Access Compliance Report Public Rights-of-Way (Curb Ramps)

Intersection ID: 48374 Main Street: REDBUD ST **Cross Street: TATE_ST** Location: NW **Severity Score: Overall Compliance: No** ADA ID: DB687627D531 Ramp Type: Para Initial Pass/Fail: Fail 22.5

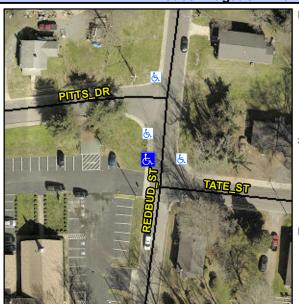
Possible Solutions:	9
Remove & Replace Entire Ramp.	ı
·	١
	1
	1
	1
	ı
Surveyor Notes:	ı
RT RP < 5%	N
	ı
	N
	N
PROW/ADA:	N
R304.5.1, R304.3.2, R304.5.3	N
	ŀ
	N

Field Measurements/Component Compliance							
Comp	liance Description	Data	Comp	liance Description	Data		
N/A	Ramp Length LT (in)	70.0	N/A	Ramp Length RT (in)	74.0		
Yes	Ramp Width LT (in)	48.0	No	Ramp Width RT (in)	47.0		
No	Ramp Slope LT (%)	9.4	Yes	Ramp Slope RT (%)	3.7		
No	Ramp XSlope LT (%)	2.2	No	Ramp XSlope RT (%)	2.3		
N/A	Landing Length (in)	N/A	N/A	DWS Provided?	N/A		
N/A	Landing Width (in)	N/A	N/A	DWS Contrast?	N/A		
N/A	Landing Slope (%)	N/A	N/A	DWS Length (in)	N/A		
N/A	Landing X Slope (%)	N/A	N/A	DWS Full Width?	N/A		
N/A	Landing Curb? (Y/N)	N/A	N/A	DWS Offset (in)	N/A		
N/A	Shared Landing?	N/A					
N/A	Gutter Ponding?	N/A	N/A	Gutter Slope (%)	N/A		
N/A	Gutter Lip Ht (in)	N/A	N/A	Gutter X Slope (%)	N/A		
N/A	Painted X Walk1?	No	N/A	Painted X Walk2?	N/A		
	X Walk 1 Direction	To E		X Walk 2 Direction	N/A		
N/A	X Walk 1 Width (in)	N/A	N/A	X Walk 2 Width (in)	N/A		
	X Walk 1 Slope (%)	7.2		X Walk 2 Slope (%)	N/A
